**STAFF REPORT: JULY 10, 2024 MEETING**  
**APPLICATION NUMBER: HDC2024-00322**  
**ADDRESS: 4340 GLENDALE**

**HISTORIC DISTRICT: RUSSELL WOODS-SULLIVAN**  
**APPLICANT: PETER BERNARD**  
**PROPERTY OWNER: AFIWI LLC (PETER BERNARD, AGENT)**  
**DATE OF PROVISIONALLY COMPLETE APPLICATION: JUNE 17, 2024**  
**DATE OF STAFF SITE VISIT: JUNE 20, 2024**

**SCOPE: REAPLACE WINDOWS (WORK STARTED WITHOUT APPROVAL), INSTALL FENCE (WORK COMPLETED WITHOUT APPROVAL), PAINT DWELLING**

**Figure 5: View of replacement windows on west side of property.**

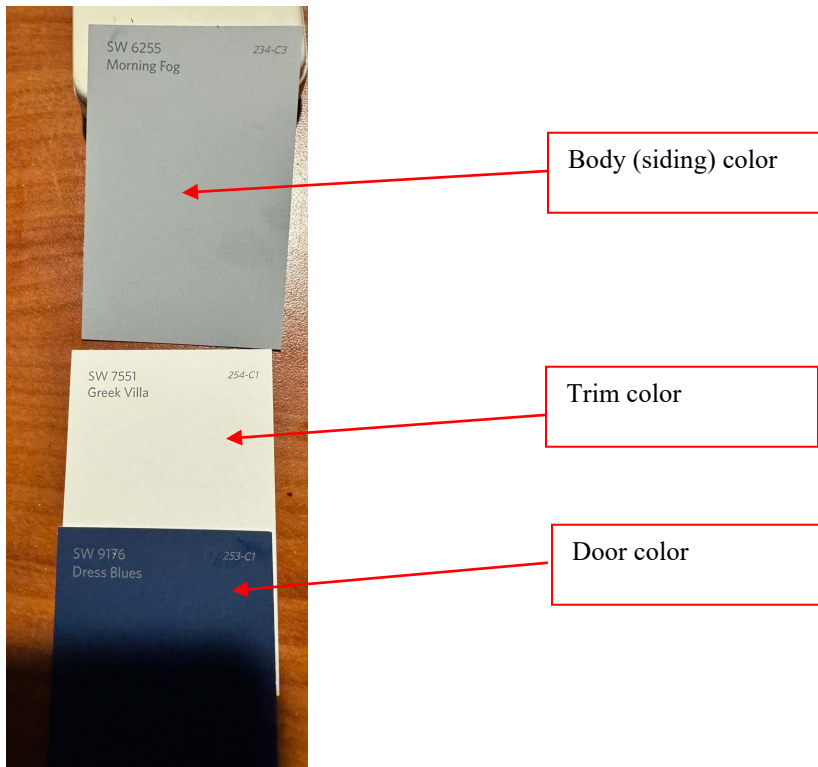
- The replacement windows on the dwelling, (both those installed ca. 2008 and the 2024 windows), are not appropriate replacements for the original windows. They do not adequately resemble the original units in terms of dimensions, materials, lite divisions, and often operation. Vinyl windows are not appropriate replacements for wood sash windows, due to their synthetic appearance and poor durability. Staff

recommends the Commission issue a denial for all of the vinyl replacement windows.

It is staff’s opinion that the proposed (and partially completed) vinyl window installation and window infill is not appropriate. Vinyl windows are not an appropriate replacement for the wood sash windows. Staff recommends that the Commission issue a denial for the proposed new window installation because the work does not meet the Secretary of the Interior’s Standards for Rehabilitation, in particular Standards 2 and 6:
